03-2019 LATEST REVISION DATE APPROVED BY BRIDGE ENGINEER	 STANDARD DESIGN ROADSIDE DYNAMIC MESSAGE SIGN (DMS) SUPPORT APRIL, 2013
	SUPPORT FRAME DETAILS
	RDMS-02-13

SECTION D-D

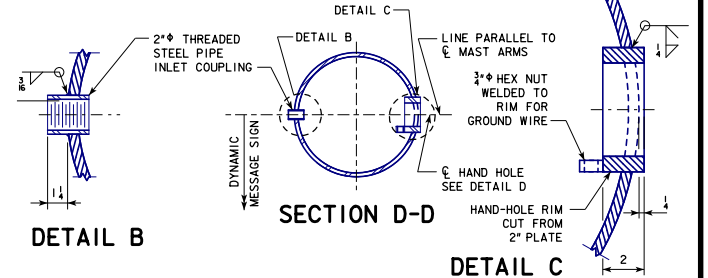
*REVISED 03-2019, MODIFIED FASTENER NOTE TO ADDRESS CHANGE IN ASTM SPECIFICATIONS. ADDED LABEL FOR DETAIL ASSOCIATED WITH SECTION D-D AND CHANGED DETAIL C LABEL TO DETAIL D.
 *CORRECTED WELD SYMBOL ASSOCIATED WITH HAND HOLE RIM. UPDATED IOWA DOT LOGO IN TITLE BLOCK. UPDATED BRIDGE ENGINEER SIGNATURE.
 *ROADSIDEDYNAMICSSUPPORT.DGN - RDMS-02-13 - THIS SHEET ISSUED 04-2013.
